Planning

Delegated Officer Report

Application reference:	145491/JO/2026
Application type:	Removal/variation of conditions
Proposal:	Variation of Conditions 2 (specified plans), 4 (waste management), 5 (cycle parking), 6 (electric vehicle charging points), 7 (landscaping scheme) and 10 (car parking) and removal of Condition 21 (rear garden amenity space) attached to planning permission 142731/JO/2025 to amend rear landscape garden with the inclusion of four car parking spaces to the rear and one additional car parking space to the front
Site address:	515 To 521 Barlow Moor Road Manchester M21 8AQ
Ward(s):	Chorlton Park
Date application valid:	27 March 2026
Applicant name:	Mr Peter Armistead
Agent (if any):	Mrs Carol Clarke
Case officer:	Holly Wright
Recommendation:	Refuse
Date of recommendation:	20 May 2026

Figure from committee report of 127241/FO/2020 showing car parking area initially proposed

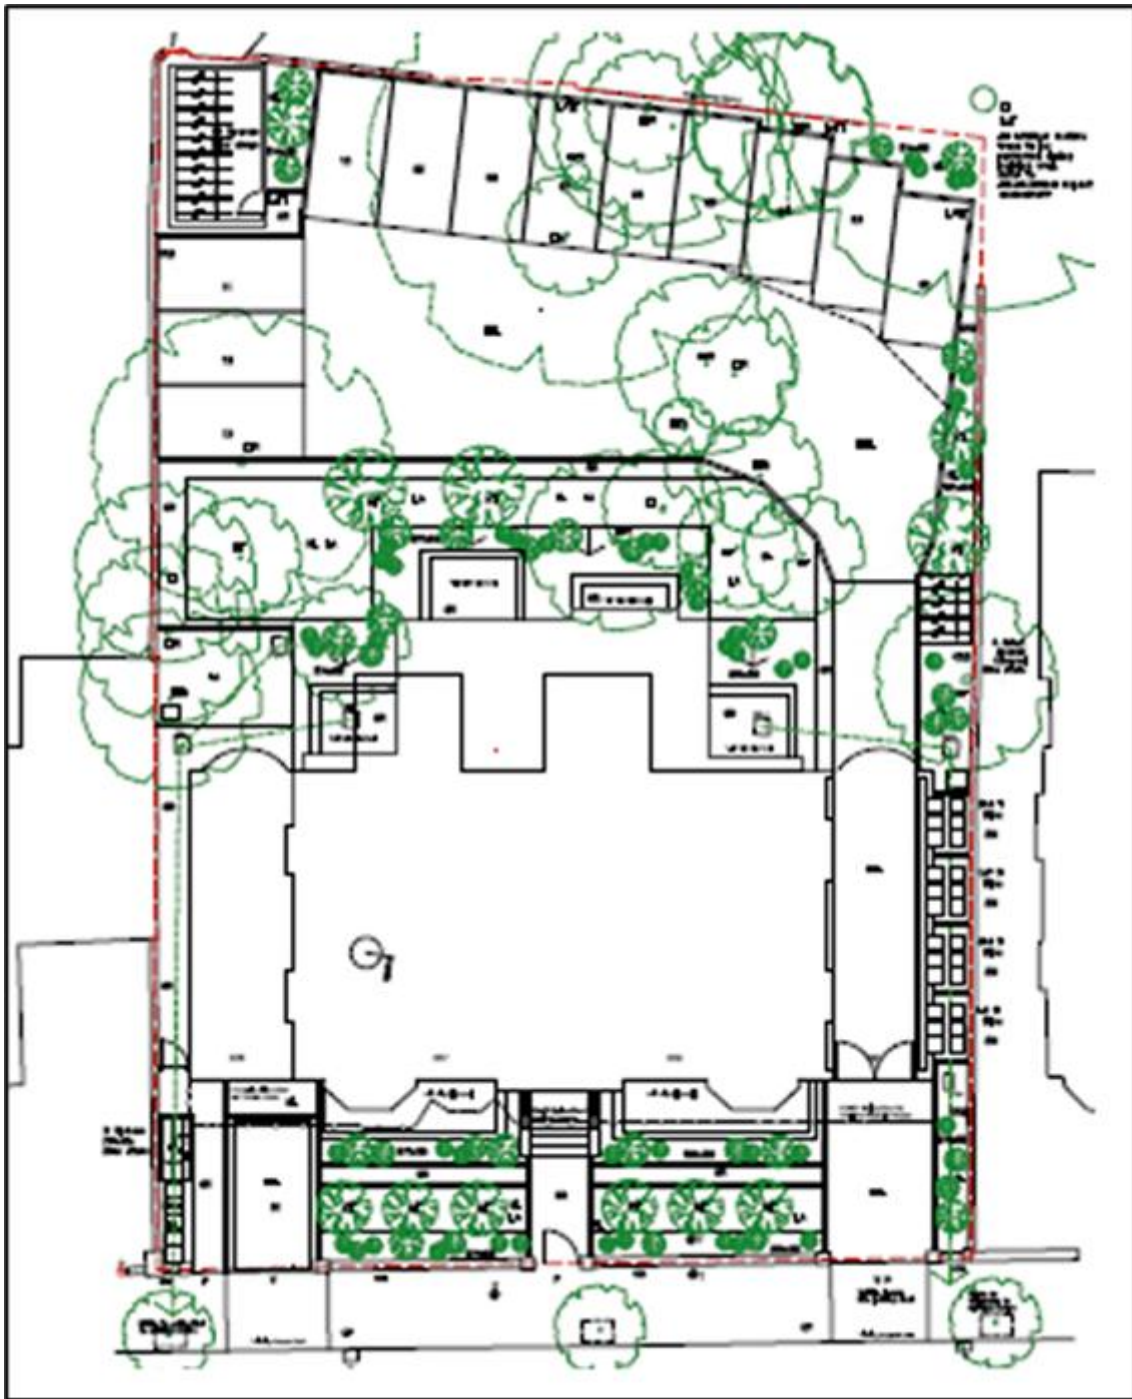
Under the original application 127241/FO/2020, a rear car parking area featuring 12no. parking bays along the southern and western borders of the plot was initially proposed (see figure included below). However, this was intentionally omitted from the proposal following negotiations between the case officer and the agent during which concerns regarding the impact that converting the rear garden space into car parking would have upon the local environment and amenity of surrounding residents were raised. The case officer also highlighted that, due to the site's sustainable location in Chorlton District Centre, it was not considered necessary to provide 100% parking provision for the proposed flats and dwellinghouse. Following this, the area to the rear of the building was intentionally revised to include 8no. hard-landscaped flag and gravel patio areas, enclosed by hedging to create semi-private amenity spaces for prospective occupiers of the development (rather than car parking). These amenity areas were to be set within an enhanced landscaped environment, incorporating new shrub and tree planting to reinforce privacy, residential amenity, and landscape quality within the development. A condition was also attached to the permission which sought to safeguard the use of this space for amenity purposes and prevent its future use for car parking.

Excerpt from drawing '2502/P/100 Revision F' (left) versus excerpt from site plan approved under 142731/JO/2025 (right)

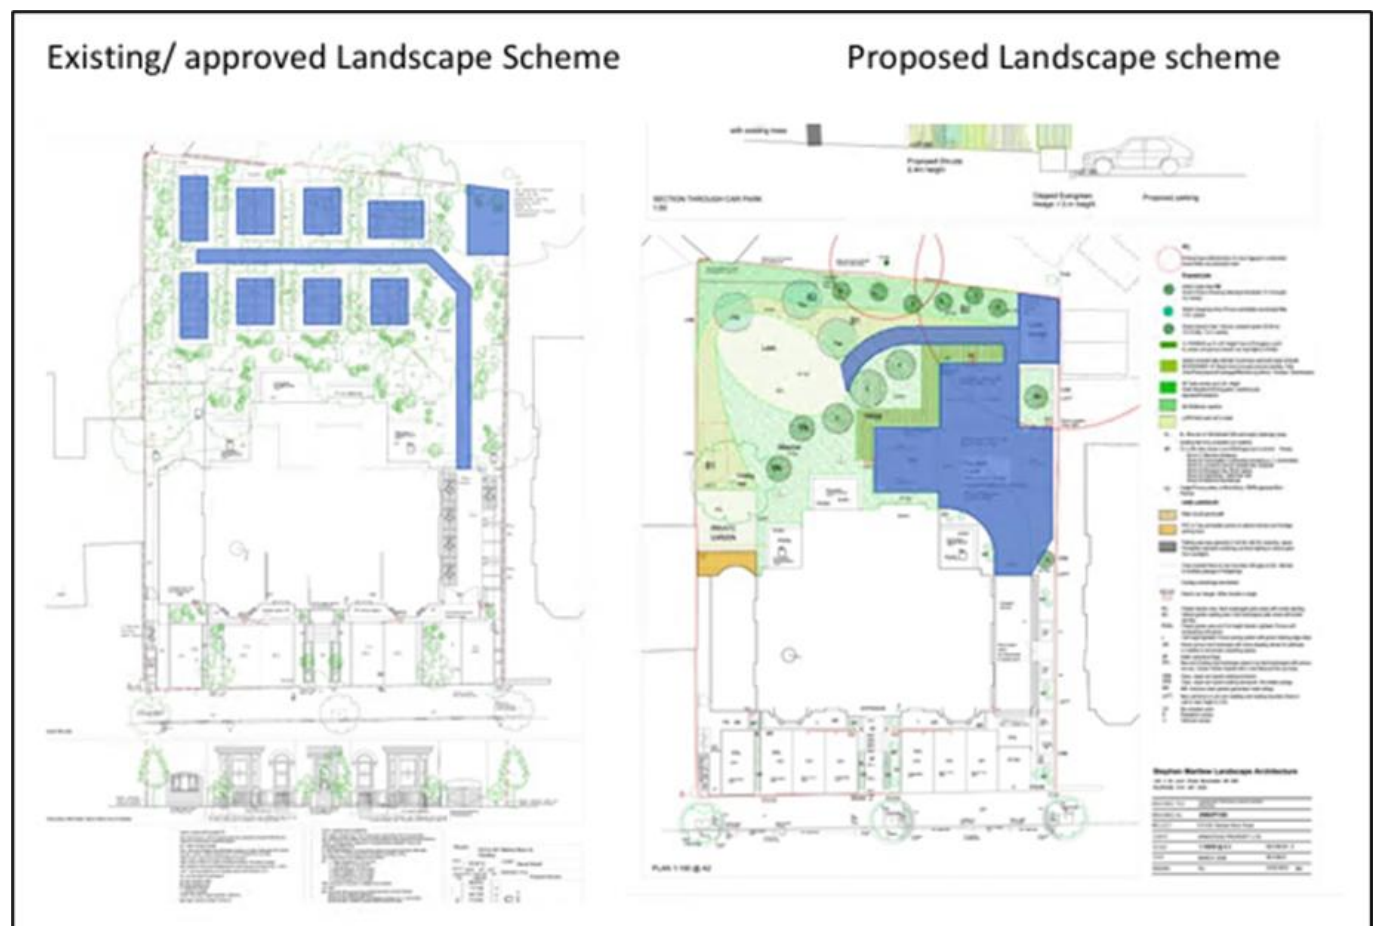
Landscape character and setting – the proposal seeks to amend the wording of condition 2 (specified plans), 7 (landscaping), and 10 (car parking) attached to 142731/JO/2025 to include the revised site plan drawing '2502/P/100 Revision F', superseding the previous site plan labelled 'Variation Application: Proposed Site Plan', numbered '149-PL-GL(2)' as well as seeking the removal of condition 21 (rear garden amenity space) to allow for the parking of vehicles to the rear of the building.

The revised site plan introduces an area of porous asphalt surfacing to the rear of the building adjacent to the plot's northern shared boundary which is proposed to accommodate 4no. car parking spaces. The remainder of the rear space is proposed to feature soft landscaping elements, including a lawn, native wildflower meadow, mixed shrub planting, hedging, and trees. Irrespective of the soft landscaping elements proposed, the aforementioned changes are considered to significantly alter the nature, character, and intended function of the rear of the site when compared to that which was considered and approved under the previous permissions 127241/FO/2020 and 142731/JO/2025

Irrespective of the reduction in hard landscaping proposed to the rear of the building (of which 11.5% is not considered to be a significantly meaningful amount), it is clear that the agent and planning submission overall have failed to consider the fundamental change in the nature, character, and use of this space, which cannot be captured by a quantitative analysis and comparison of hard landscaping alone. As indicated previously, by introducing an area of car parking to the rear of the site, the current proposal effectively undermines and erodes the carefully considered and negotiated design approach secured through the previous planning permissions 127241/FO/2020 and 142731/JO/2025 as it would convert what was originally intended to function as a pedestrianised, private, and tranquil amenity space into an area characterised by vehicular activity, associated noise, and disturbance. Moreover, whilst the proposal does include an area of soft landscaping intended to function as an “informal garden area” (as suggested on page 1 of the planning statement received 20th March 2026), its proximity to the proposed parking bays significantly reduces its quality and use as the presence of vehicles, movements, and associated activity would erode both the sense of privacy and quiet enjoyment of this space, irrespective of the planting measures proposed between the two areas.

For these reasons, the proposal is considered to represent a significant departure from the previous approvals and would materially diminish the quality of the approved development, thus undermining the certainty and integrity of the previous permissions as well as resulting in a harmful change to the curated landscape character and setting of the site. The proposal would therefore directly conflict with paragraph 140 of the National Planning Policy Framework (2024) which states “Local planning authorities should... seek to ensure that the quality of approved development is not materially diminished between permission and completion, as a result of changes being made to the permitted scheme” as well as saved policy DC5 of the Unitary Development Plan for the City of Manchester, policies DM1 and SP1 of the Manchester Core Strategy, policy JP-P1 of Places for Everyone, chapters 11 and 12 of the National Planning Policy Framework (2024), and chapter 14 and policies DP3 and DP4 of the draft National Planning Policy Framework (2025).

Excerpt from page 4 of the submitted summary planning statement (received 20th March 2026)

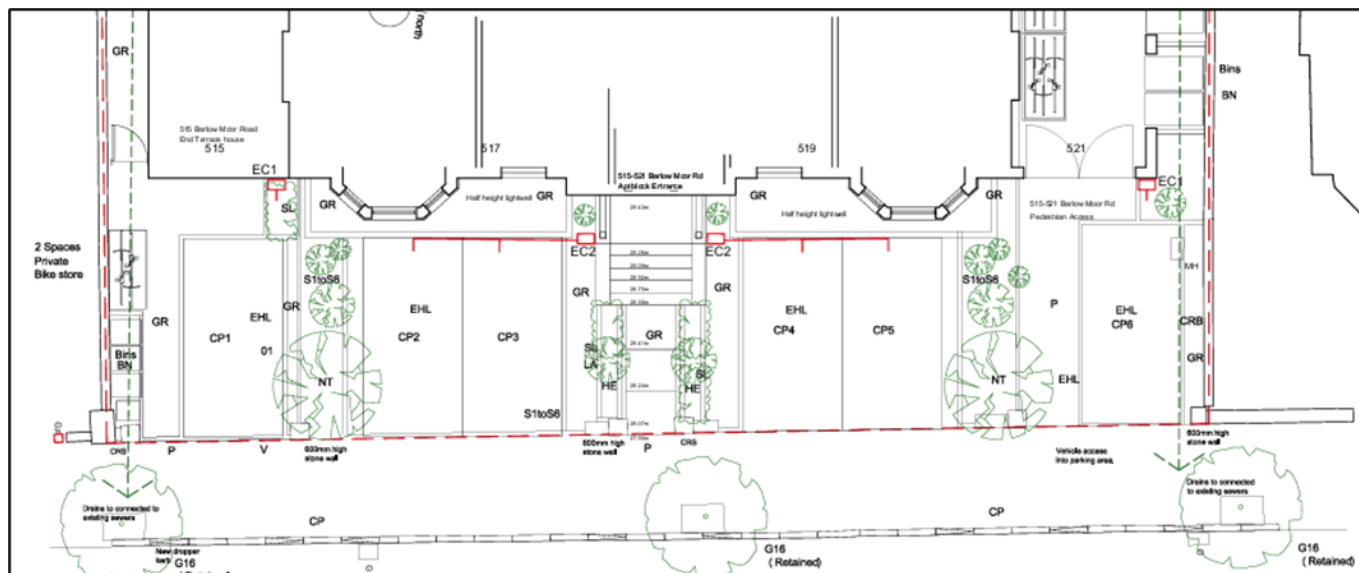
In support of the current application, the agent has argued that the proposal “does not overly urbanise the rear garden area” (page 3 of planning statement received 20th March 2026), highlighting a general reduction in the hard landscaping of this portion of the site. However, this position has been inconsistent over the course of the application with the initial planning statement (received 20th March 2026) suggesting the previously approved scheme included 200 sqm of hard landscaping, whilst the current proposal includes 157 sqm of hard landscaping, equalling a reduction of 21.5% (see pages 3 and 4). Conversely, the planning statement received on the 6th May 2026 indicates that the current proposal actually includes 177 sqm of hard landscaping, rather than the 157 sqm previously suggested, resulting in a reduction of 11.5% rather 21.5% (see page 2).

Lower-ground floor plan approved under 142731/JO/2025

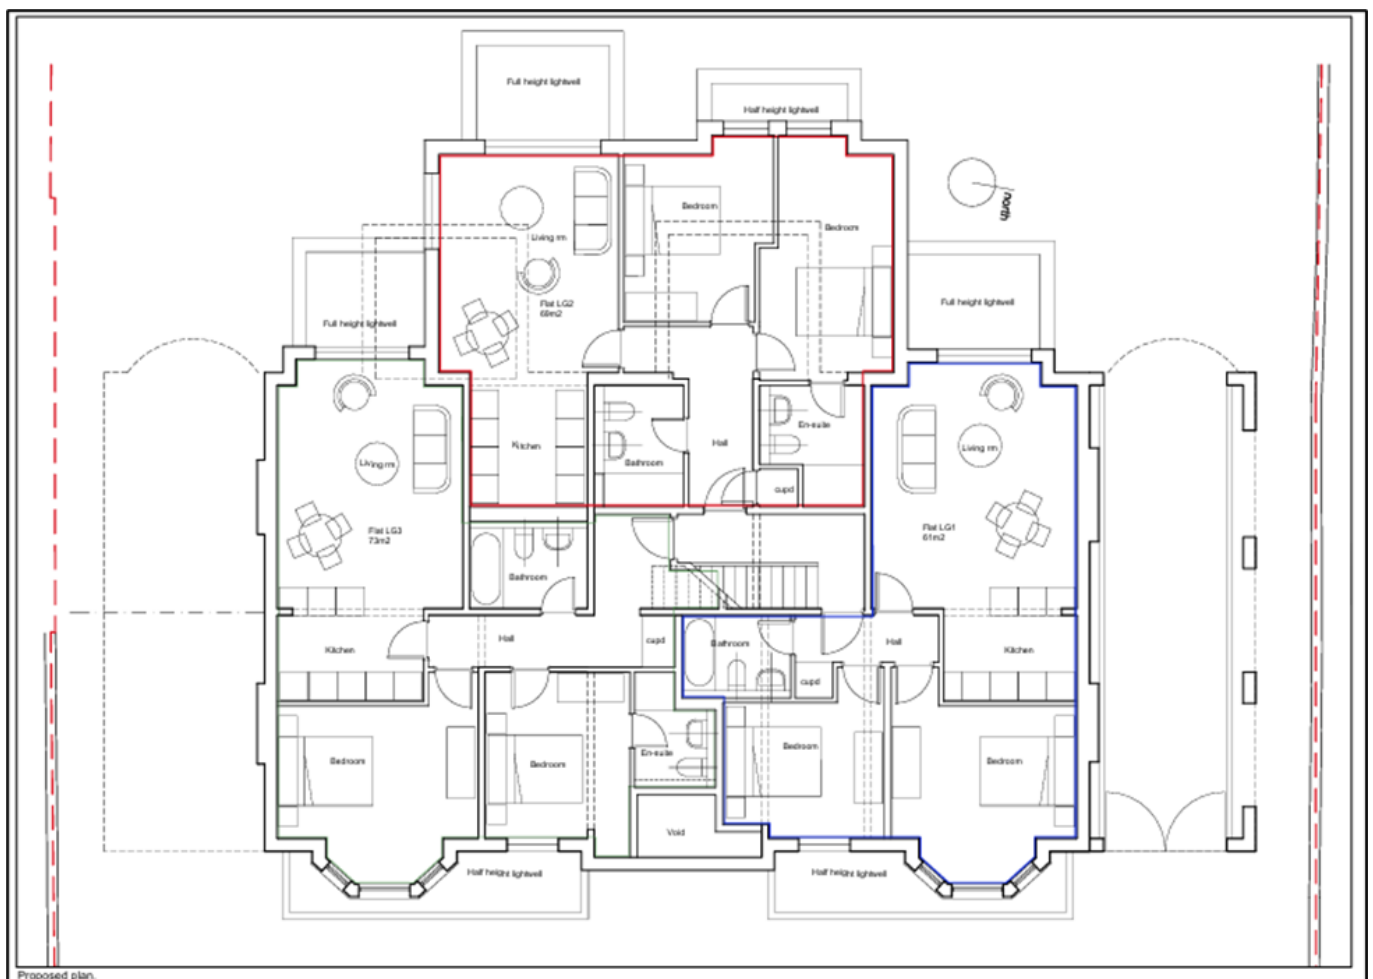
The application is also supported by a Noise Impact Assessment which suggests that the proposal would only result in a marginal increase in noise levels at surrounding residential

receptors, therefore indicating that noise would not represent an overriding constraint to the development, whilst also recommending a range of mitigation measures, including boundary fencing, low-noise surfacing, reduced vehicle speeds, and the implementation of a noise management plan. However, again, the validity and reliability of the assessment's conclusions are significantly undermined by the limitations of its methodology and resulting analysis. The assessment exhibits an overreliance on simplified and highly-controlled assumptions which are unlikely to reflect the unpredictable nature of real-world vehicle activity. Its use of short, simplified sample events fails to reflect activity such as engine revving, idling, and repeated vehicle movements, which, given the constrained nature of the undercroft access and rear parking arrangement and practical difficulties of manoeuvring into and out of the bays, are likely to occur frequently at the site. Further to this, the reliance on averaged noise levels, risks the impact of peak noise events being underrepresented in the results. Additionally, much like the submitted Lighting Impact Assessment, the Noise Impact Assessment relies on indicative mitigation measures which have not been secured through clearly defined and enforceable specifications on the submitted drawings, thus raising concerns in relation to their effectiveness and long-term implementation. Finally, the assessment also fails to adequately consider the impacts of noise upon the prospective occupiers of the development itself. This represents a significant omission, given that the scheme includes habitable rooms positioned directly adjacent to and above the undercroft vehicle access, as well as a number of habitable rooms and balconies that overlook the rear parking area (see figures included below). In these locations, future residents would be exposed to noise associated with vehicle movements in close proximity, including manoeuvring, idling, and repeated arrivals and departures. As such, it is considered that the absence of any meaningful assessment of these receptors further undermines the validity and reliability of the submitted analysis.

Irrespective of the detail provided in the submitted impact assessments, it is considered that the proposal would result in undue harm to the residential amenity of the area as it would introduce regular vehicular activity into an area that was originally intended to function as a pedestrianised, private, and tranquil amenity space. This fundamental change in the character and use of the space would result in harmful impacts upon neighbouring occupiers whose properties border and overlook the site, most notably the south-facing windows of No.523 Barlow Moor Road (sited in close proximity to the rear parking area), as well as prospective occupiers of the development itself, in terms of their lived experience, as a result of activities associated with vehicle movements, an increase in vehicular activity both throughout the day and during the evenings, with increased comings and goings, noise, music, door slams, and noise and light pollution, in an area where neighbouring residents would typically expect it to be quieter with lower levels of activity.

'149-PL-OS1 revision A Site Location Plan' (left) and '149-PL-AD1 revision E Bike shed and Bin Store' (right)

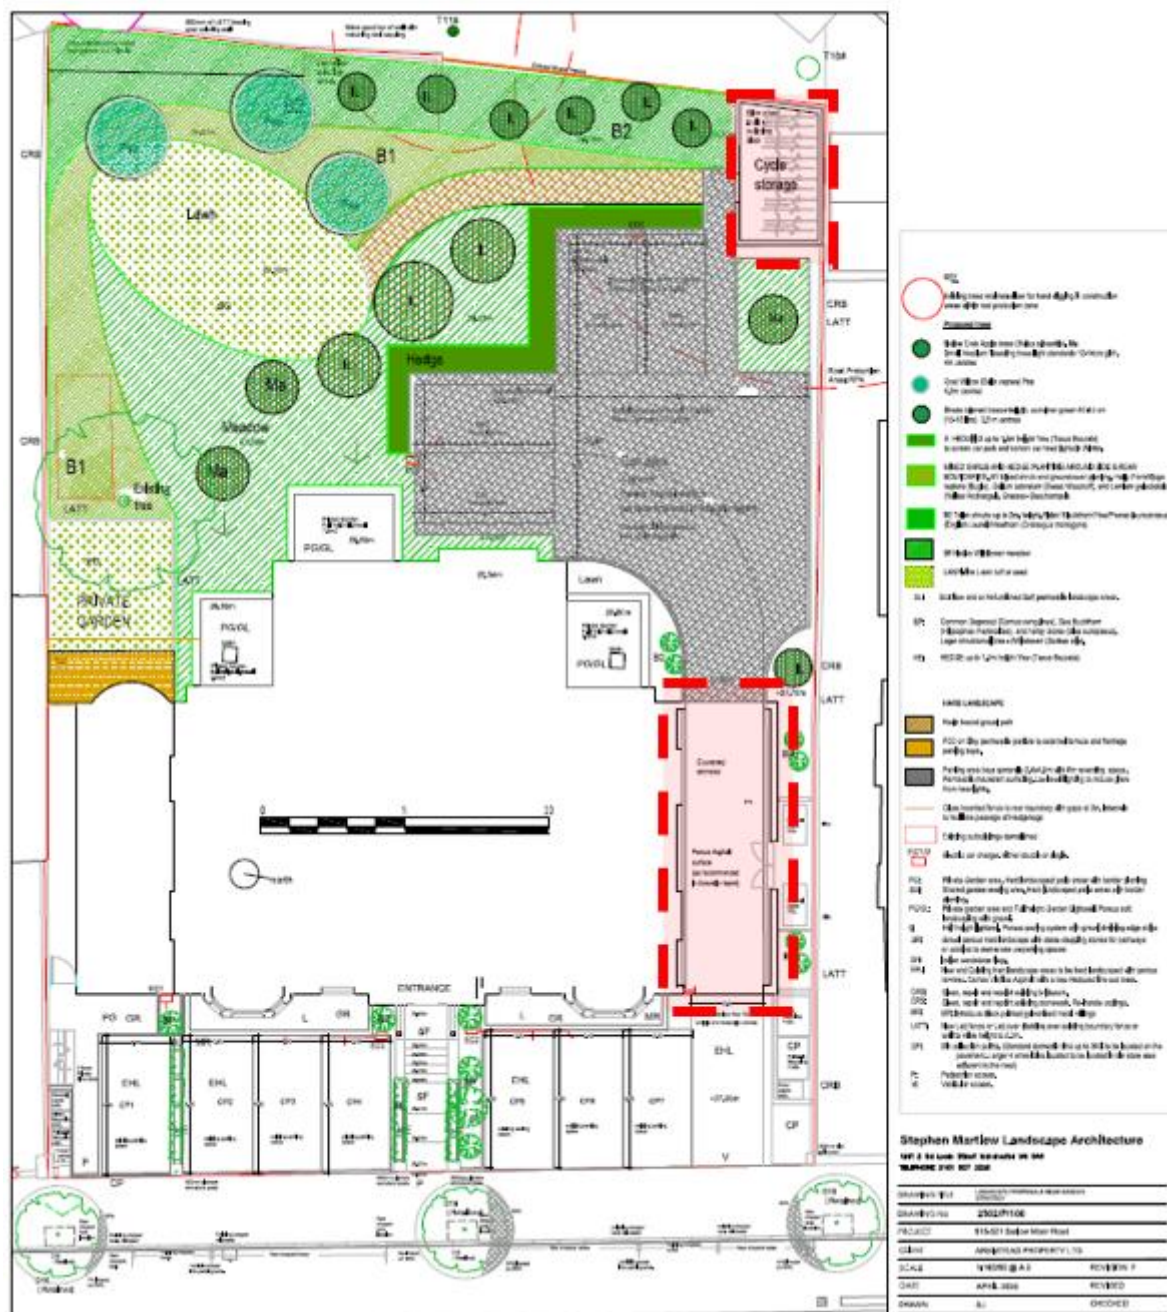
Submission discrepancies - within the document titled ‘S73 Variation of Condition Request, 515–521 Barlow Moor Road’, the accompanying table indicates that the specified plans condition should be amended to include plans omitted from the original permission 127241/FO/2020, namely ‘149-PL-OS1 Revision A – Site Location Plan’ and ‘149-PL-AD1 Revision E – Bike Shed and Bin Store’.

Whilst the inclusion of drawing ‘149-PL-OS1 Revision A – Site Location Plan’ would be permissible, it is unnecessary, as the drawing solely identifies the application site edged red on a location plan and does not illustrate any proposed works. The inclusion of drawing ‘149-PL-AD1 Revision E – Bike Shed and Bin Store’ within the specified plans condition would however directly conflict with other intents set out under the current application 145491/JO/2026. The current proposal seeks to omit the cycle storage previously located within the undercroft area and instead provide a bike shed in the northwestern corner of the site. In addition, elements of the waste storage previously shown within the undercroft are proposed to be relocated to the front of the building, as illustrated on drawing ‘2502/P/100 Revision F’. Given these discrepancies, it would not be possible to condition both ‘149-PL-AD1 Revision E – Bike Shed and Bin Store’ and ‘2502/P/100 Revision F’, as the drawings are contradictory and represent conflicting site arrangements.
